### Project #21-017 Aggie Estates 626 East 800 North

### REPORT SUMMARY...

Project Address: 626 East 800 North
Request: Design Review Permit
Current Zoning: Campus Residential (CR)

Type of Action: Quasi-Judicial Hearing Date April 22, 2021

OWNER:	JORDAN LEISHMAN
PROJECT ADDRESS:	626 EAST 800 NORTH LOGAN, UT 8432
ARCH PROJECT #:	16-0
A.O.R.:	JDI
PHASE:	DESIGN REVIEW
PUBLISH DATE:	DD MONTH YYYY
SHEET SCALE:	As indicated
SHEET NAME:	SITE PLAN

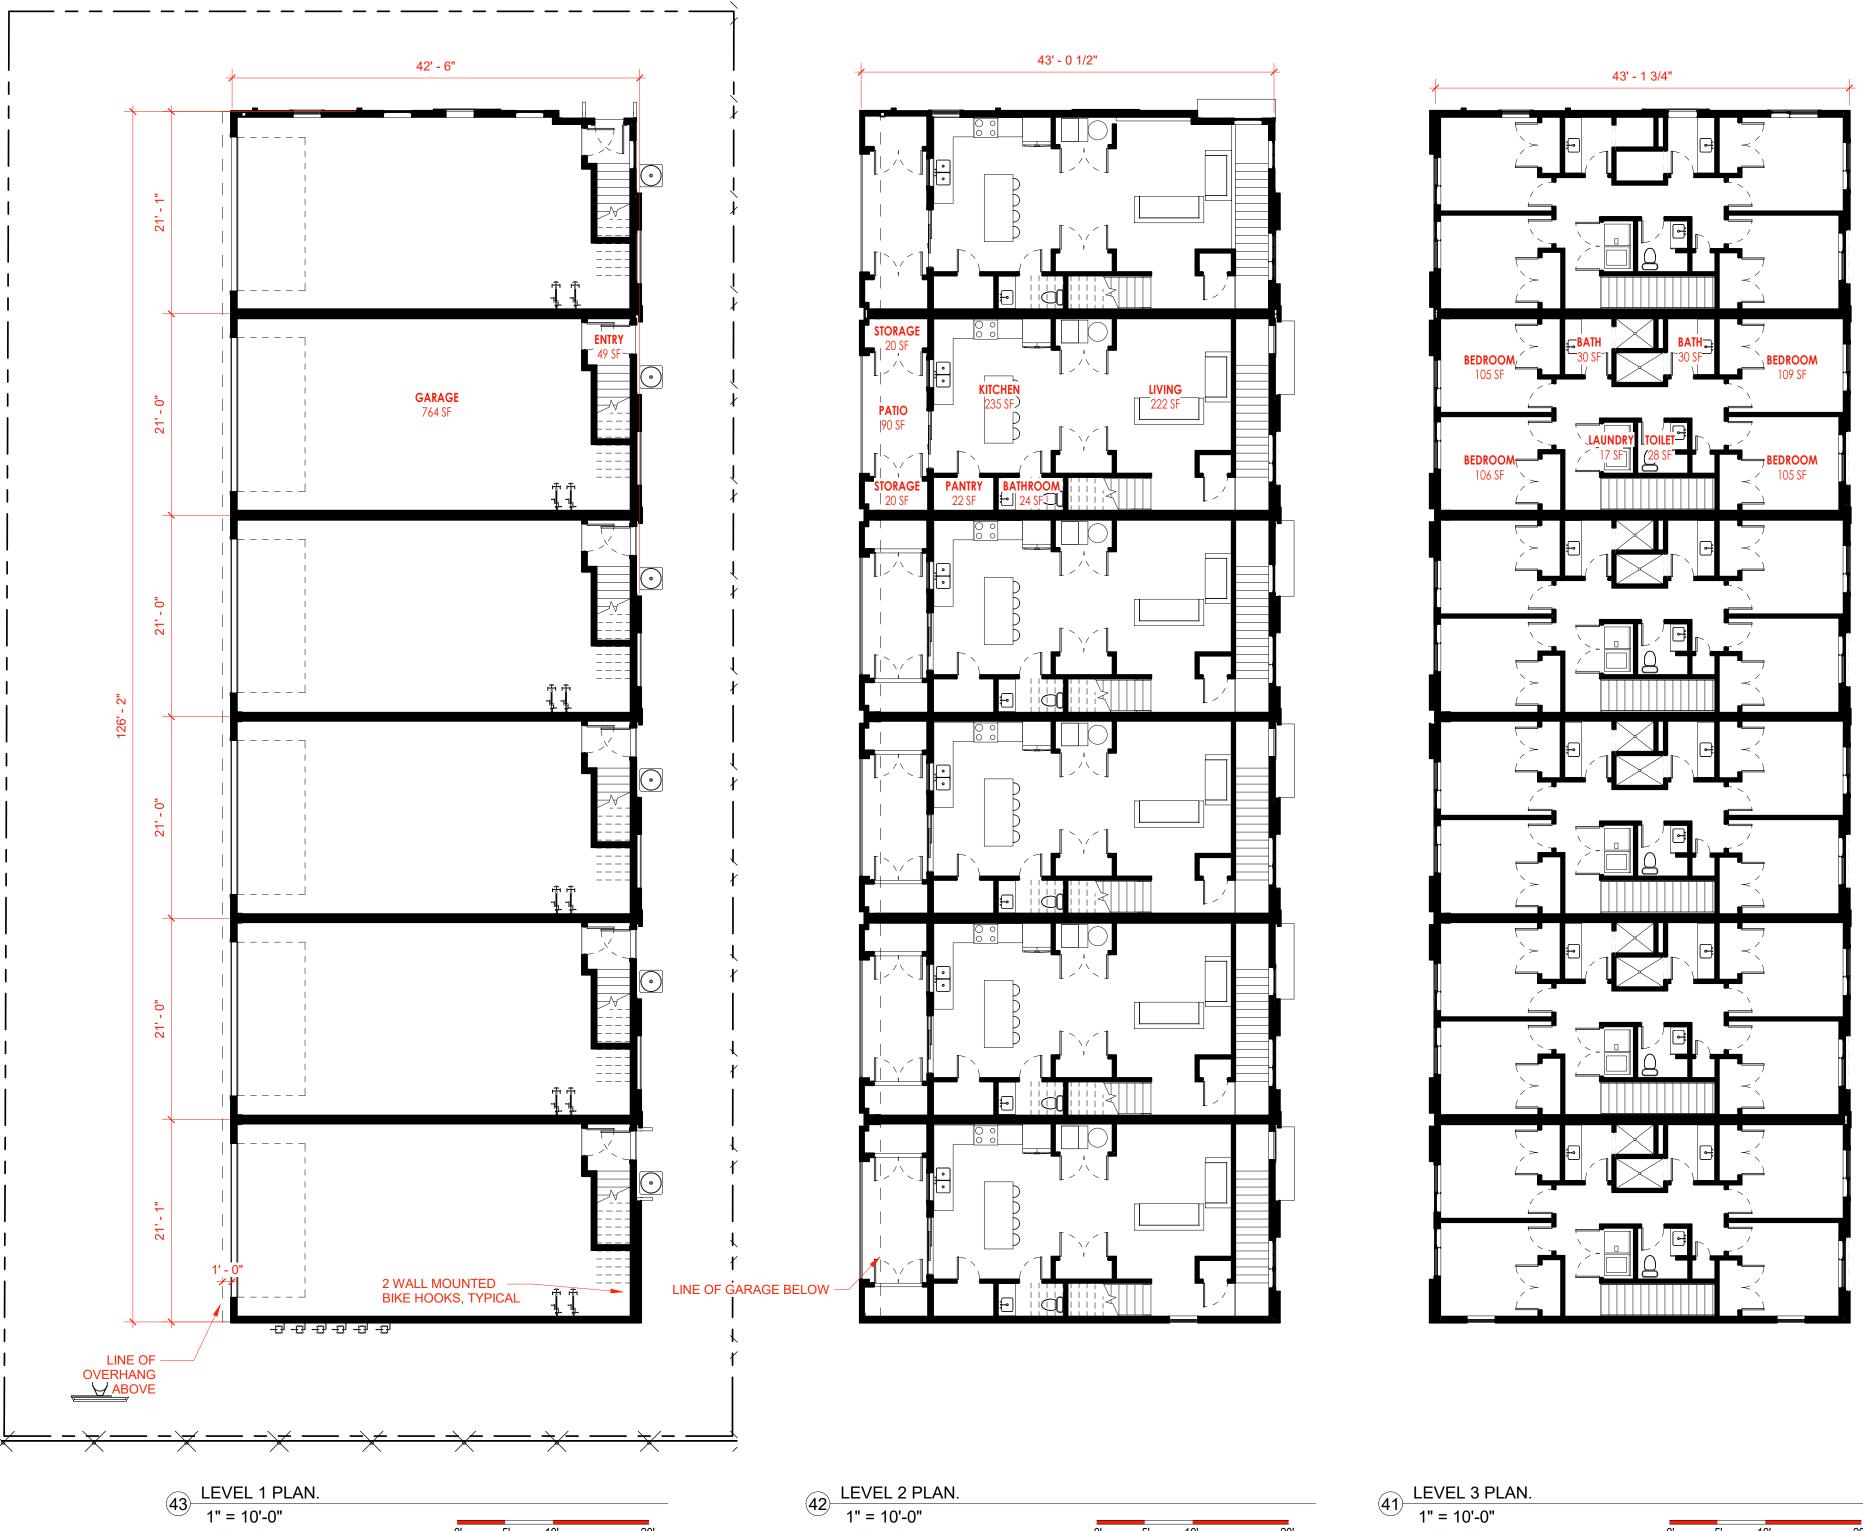
- Existing sewer and water services shall be capped at City utility main unless being reused for new development
    - Provide fixture count analysis and flows to determine if existing 1" meter is capable of supporting 6-residential units. Most likely the 1" meter will need to be upsized to a 2" meter for indoor use. The existing 1" meter could be used for irrigation only.

- If a fire line is required by the Fire Marshall, provide City with Private Water Utility Agreement
    - New sewer line not shown on Site Plan, must be sized for maximum flow from units and cannot be located under the proposed stormwater system.
